PILGRIM NUCLEAR POWER STATION, UNIT NO. 1

Amendment No. 28
License No. DPR-35

ATTACHMENT TO LICENSE AMENDMENT NO. 28

SAFETY EVALUATION BY THE OFFICE OF NUCLEAR REACTOR REGULATION
SUPPORTING AMENDMENT NO. 28 TO FACILITY OPERATING LICENSE NO. DPR-35

Figure 3.6.1 Vessel Temperature-Pressurization Limits

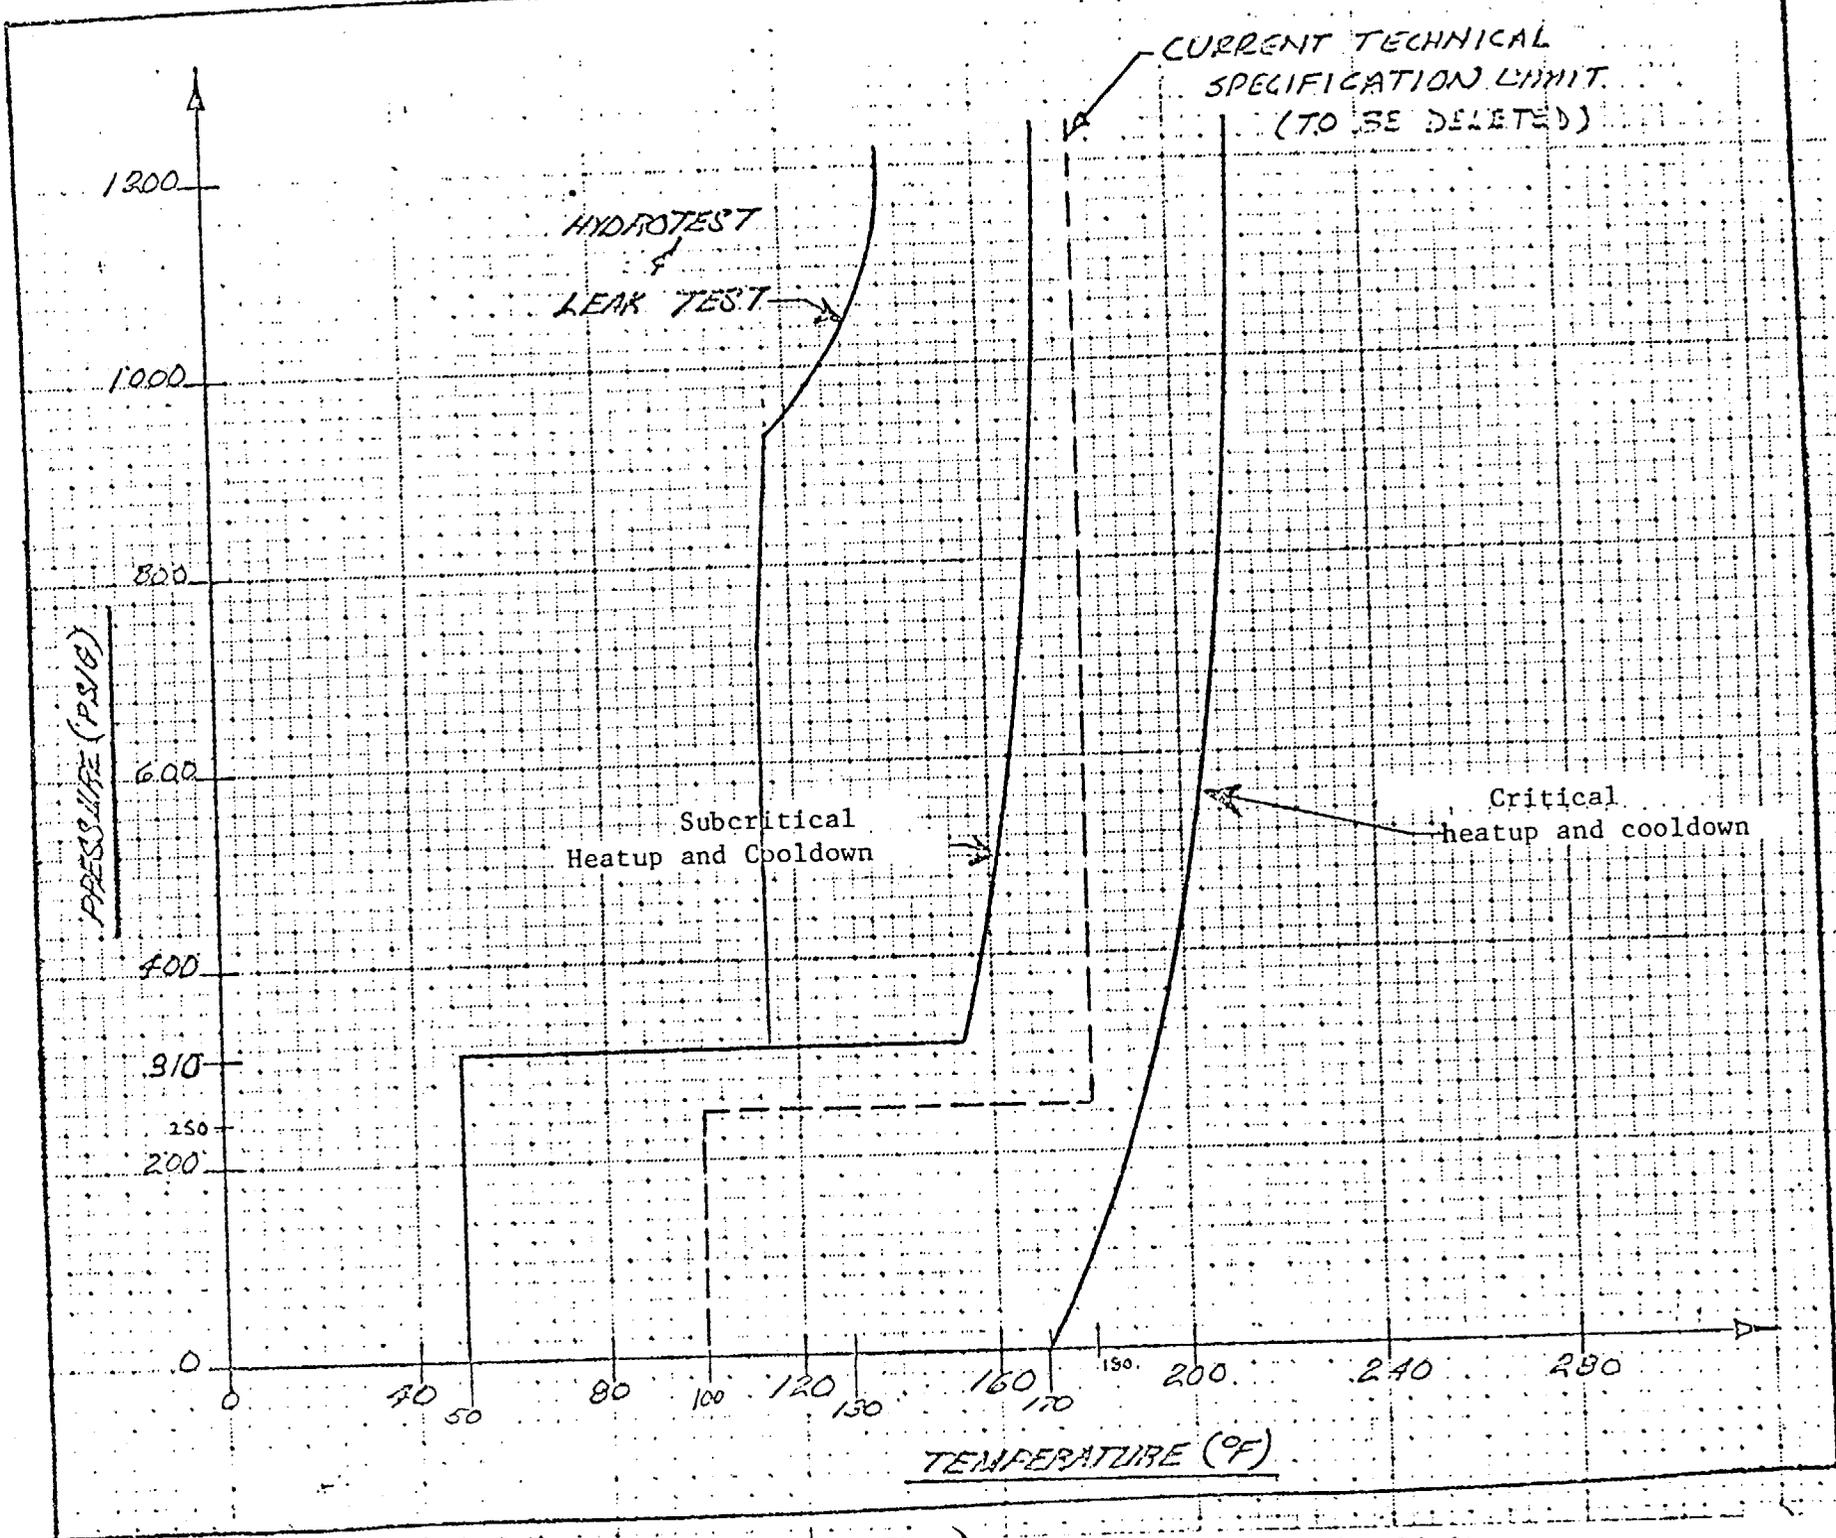
Appendix G to 10CFR50 defines the temperature-pressurization restrictions for hydrostatic and leak tests, pressurization, and critical operation. These limits have been calculated for Pilgrim I and are contained in Figure 3.6.1. For the limiting location, an $R_{t\text{NDT}}$ equal to $(-)10^{\circ}\text{F}$ is used based upon materials data. Section III of the ASME Boiler and Pressure Vessel Code requires that pressurization and stud tensioning be performed at 60°F above this reference temperature, thereby requiring the temperature to be above 50°F prior to performing these activities.

The NRC Staff has reviewed Boston Edison's proposed changes to the pressure-temperature limits for the Pilgrim Unit No. 1 vessel. These pressure-temperature limits are based on updated techniques which are detailed in the Summer 1972 Addenda to the ASME Boiler and Pressure Vessel Code, Section III. The techniques are presently required in Appendix G to 10 CFR Part 50. The techniques involve the use of the RT_{NDT} (i.e., reference RT_{NDT} plus any radiation induced shift) which is in turn used to index the material to a reference stress intensity factor curve which appears in Appendix G of the ASME Code. The curve in the Code provides the stress intensity factor for the material and this stress intensity factor serves as an allowable upper limit in the analysis. Actual stress intensity factors are then determined by combining the effects of pressure stress and thermal gradient stress. The allowable stress intensity factor must then be larger than the actual stress intensity factors with appropriate safety margins included. The analysis then consists of determining limiting conditions within these guidelines for the allowable combination of vessel pressure and temperature. For the Pilgrim Unit No. 1 vessel, the initial value of RT_{NDT} is $-10^{\circ}F$ for the limiting region of the vessel, the upper shell adjacent to the shell flange.

The licensee's proposed pressure-temperature operating limits for hydrostatic leak testing, subcritical heatup and cooldown, and critical heatup and cooldown have been calculated in accordance with Appendix G to 10 CFR Part 50 and Appendix G to ASME Code Section III. These limits are based upon an analysis by Teledyne Materials Research Engineers entitled - Evaluation of Pilgrim Unit No. 1 Reactor Vessel Pressure Boundary to Appendix G ASME Code Section III (TR-2318, Rev. 1).

Figure 3.6.2 Reactor Pressurization Temperature Adjustment

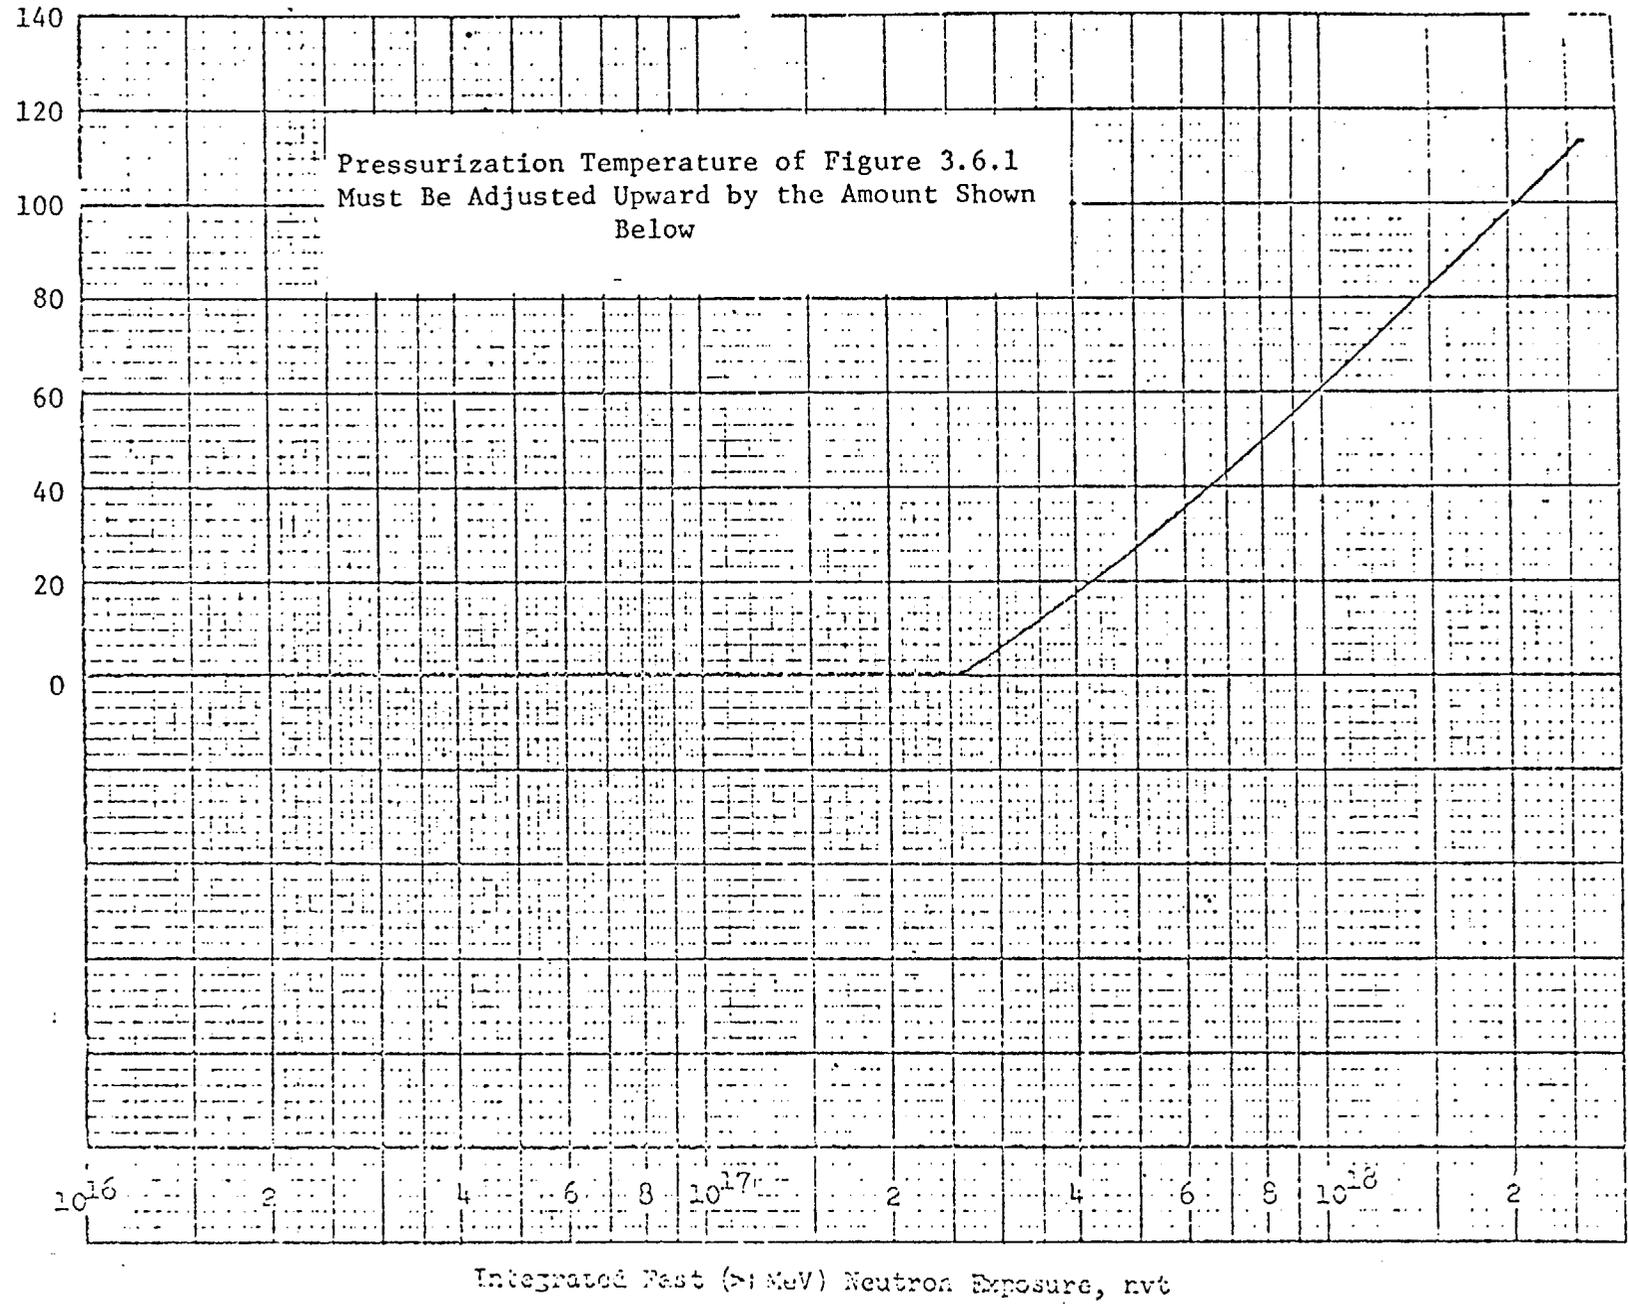
1. The average rate of reactor coolant temperature change during normal heatup or cooldown shall not exceed 100°F/hr when averaged over a one-hour period except when the vessel temperatures are above 450°F . The shell flange to shell temperature differential shall not exceed 145°F .
2. The reactor vessel shall not be pressurized, hydrostatic and/or leakage tests shall not be performed, and critical core operation shall not be conducted unless the reactor vessel temperature is above that defined by the appropriate curve on Figure 3.6.1. For integrated fast neutron exposure greater than approximately 2.5×10^{17} NVT, the curves of Figure 3.6.1 shall be adjusted upward by an amount as shown on Figure 3.6.2.

neutron flux specimens shall be removed at the frequency required by 10CFR50 Appendix H and tested to experimentally verify or adjust the calculated values of integrated neutron flux that are used to determine the NDTT for Figure 3.6.2.
